LBC FOR NEW WINDOW TO FIRST FLOOR CURRENT ENSUITE AS  
19/07877  
THIS PROPOSAL ALSO FOR REPLACEMENT WINDOW TO FIRST FLOOR  
SOUTH ELEVATION INDICATED ON PLANS

| 886-P-011           |       | LANGLEY GREEN HOUSE     |          |                                  |  |
| Revised Sash Detail |       | hra                     |          |                                  |  |

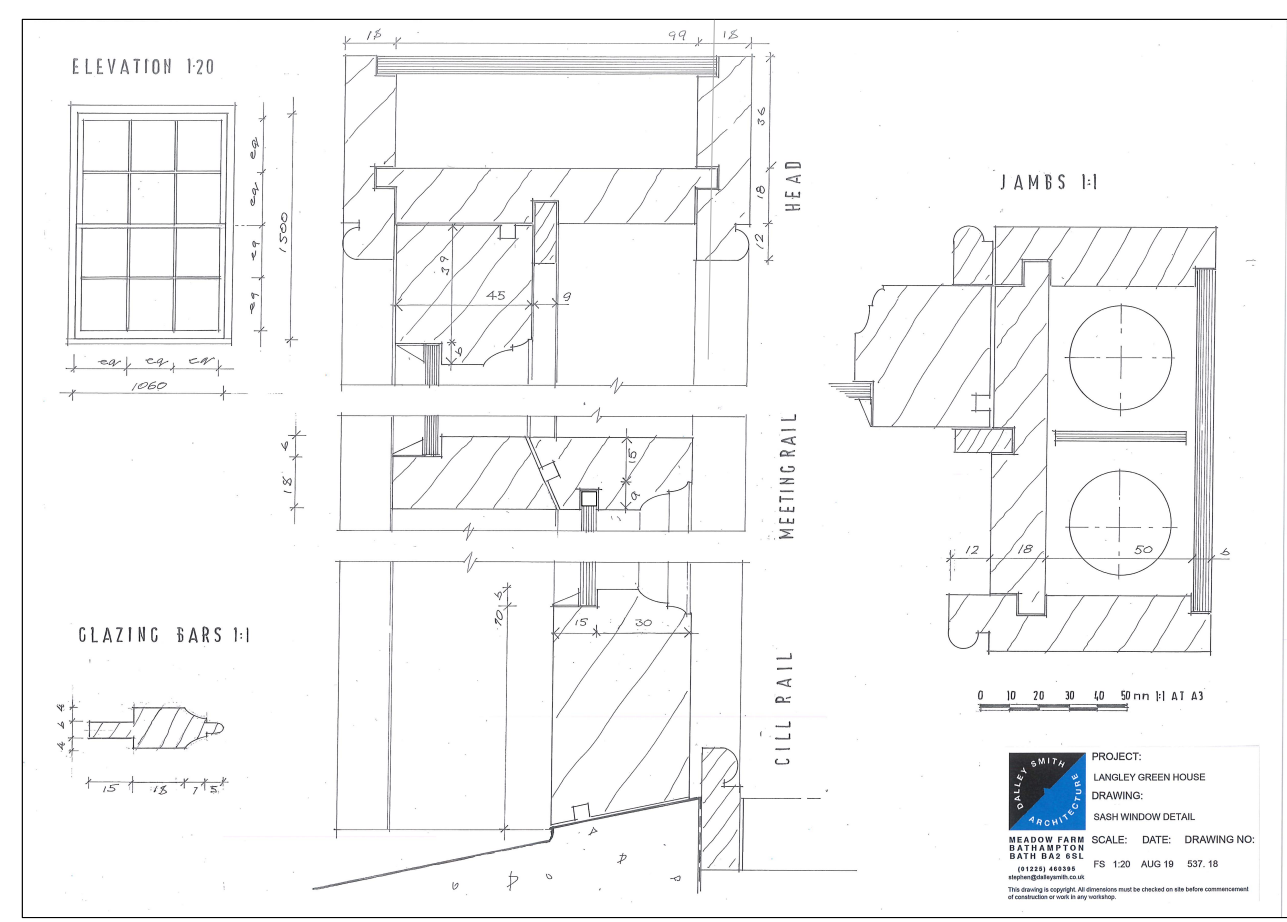
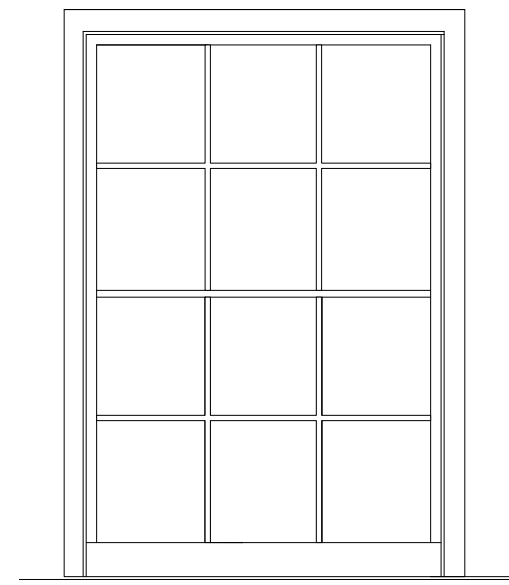
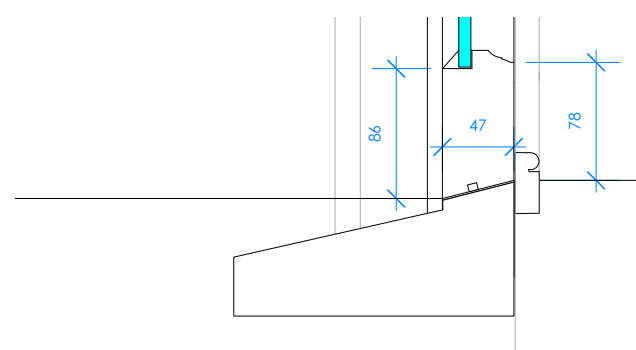
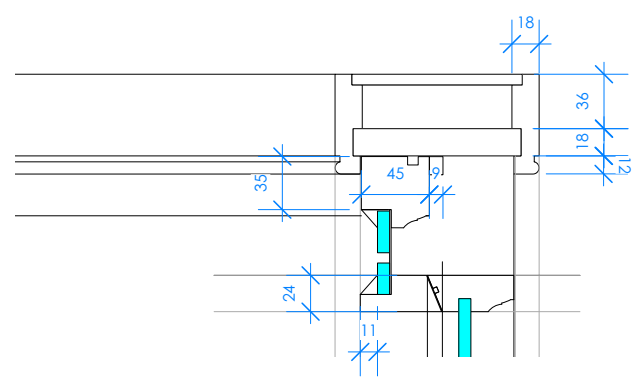
ORIGINAL CONSENT USES HISTOGLASS MONO RT+  
U VALUE 3.6 WmK 2 AS AGREED WITH LBO

PROPOSAL IS TO USE FINEO GLASS 7.7MM GLASS TO GIVE IMPROVED  
U VALUE OF .7 w/M2k

ALL TIMBER SECTIONS OF SIMILAR SIZE TO MATCH EXISTING
